Network Keyboard 1100KI (B)

Version: V4.0.2

Release Note

(2019-08-05 External)

3.【Screen changes】

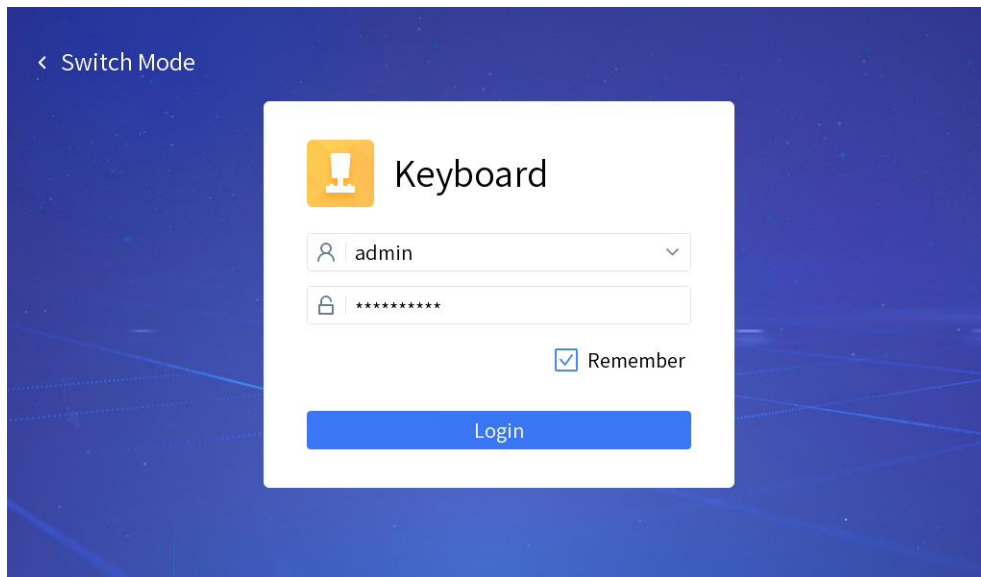
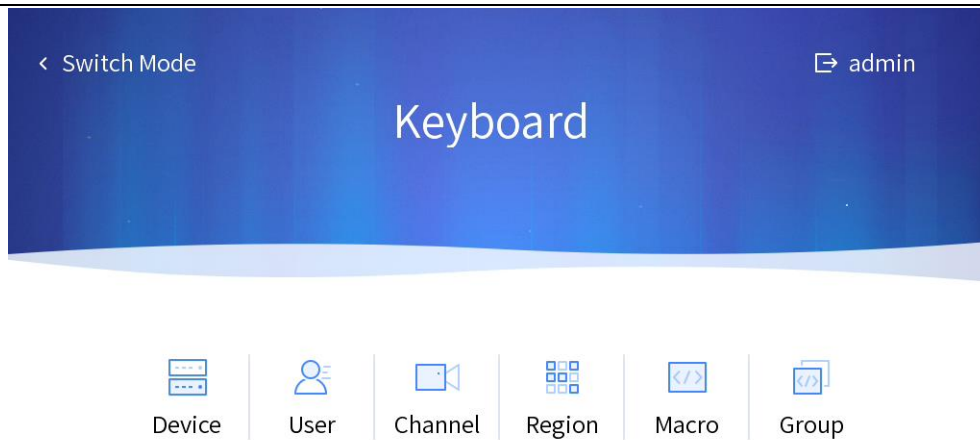
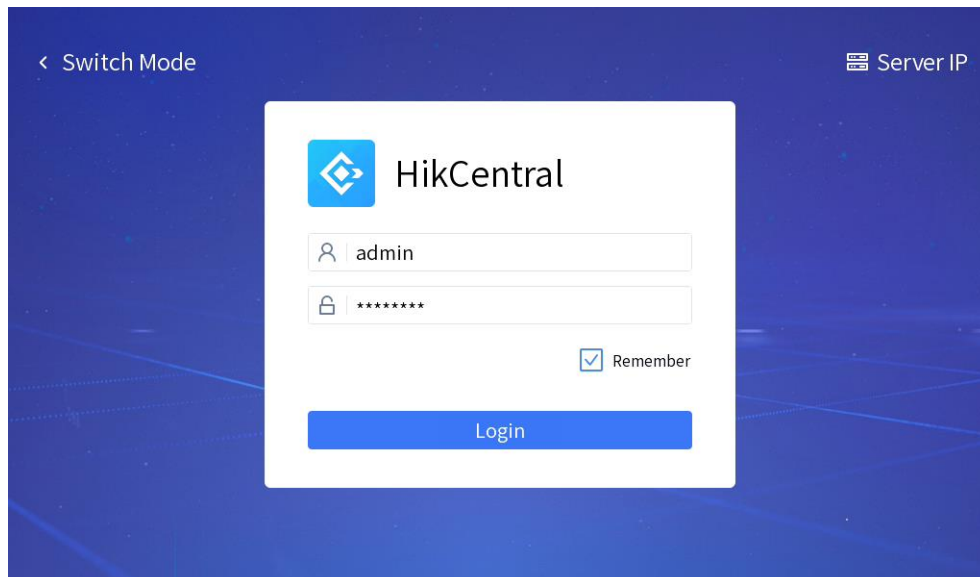
V3.xx devices support Angle 800x480 resistive touchscreen, V4.xx devices support Angle 1024x600

capacitive touch screen.

## 4.【UI changes】

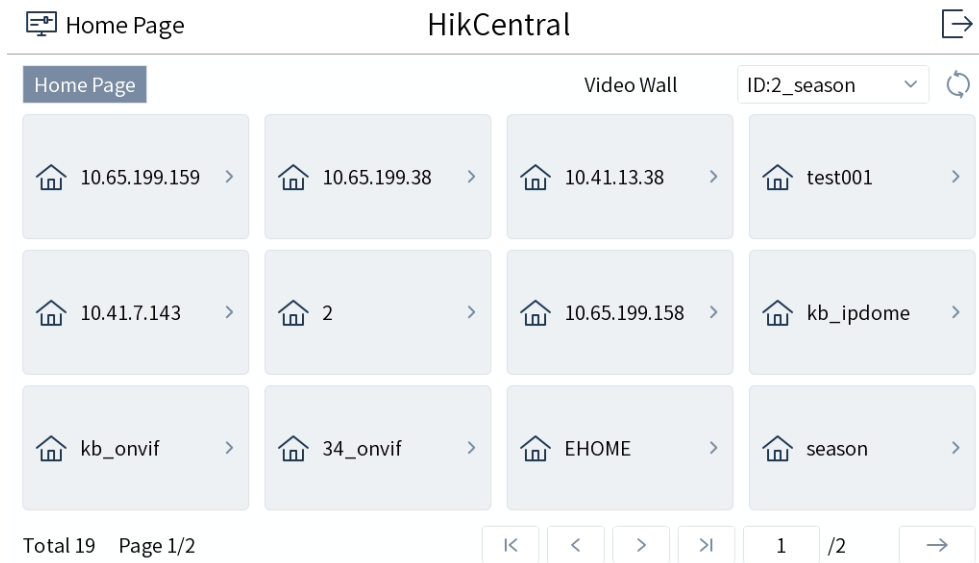
New Home interface UI.

New Keyboard Login UI

New Keyboard Mode interface

5.【Support HikCentral Platform】

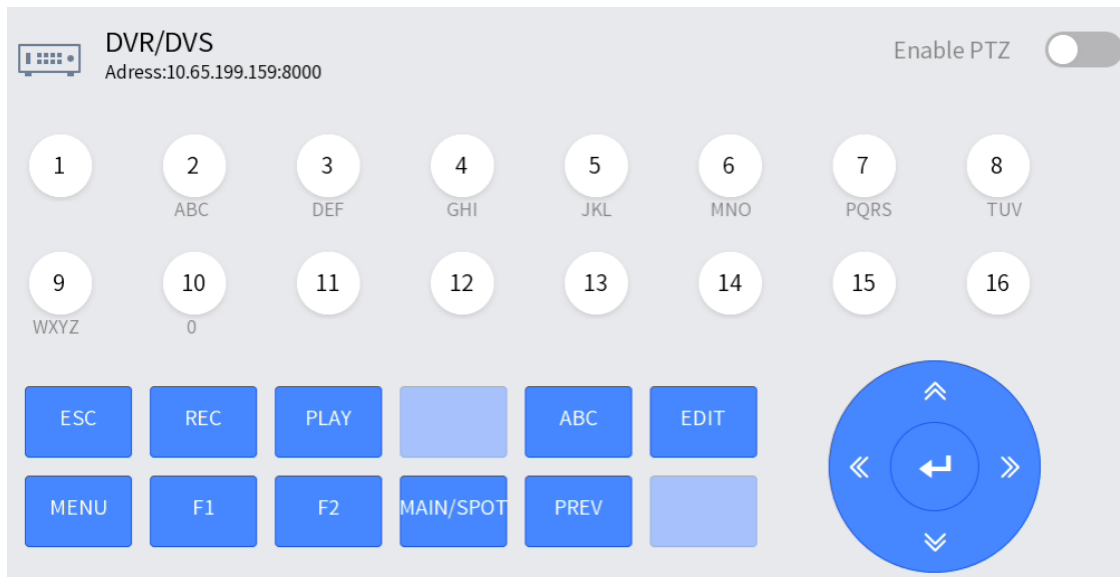
Support HikCentral (V1.4.0) TV wall function (display layout, switch on the wall, scene switching, window, image segmentation, etc.)

New HikCentral Login interface

New HikCentral Video Wall management

7.【Support Local Playback and Instant Playback】

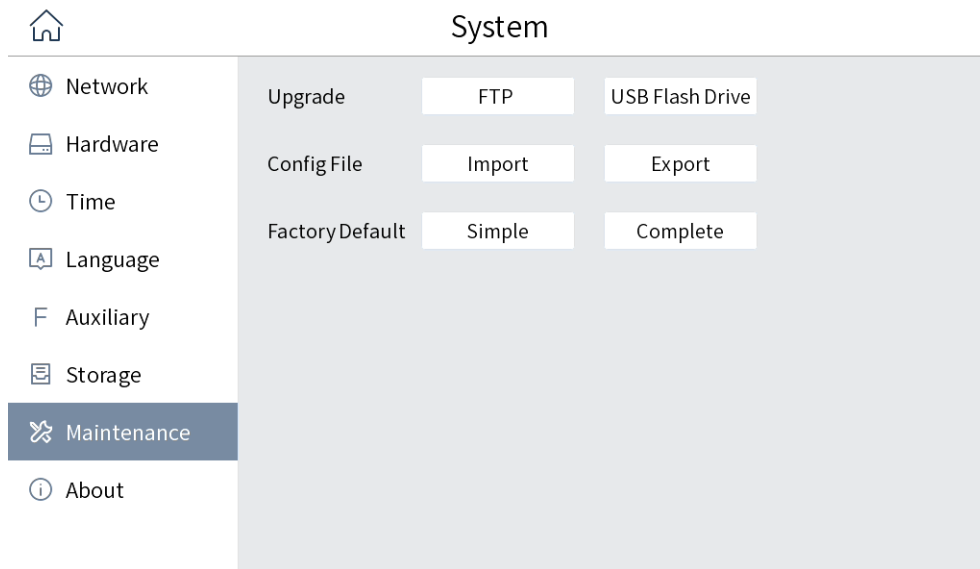
Support playback video files on the hard disk video recorder and instant playback in last 5 minutes.
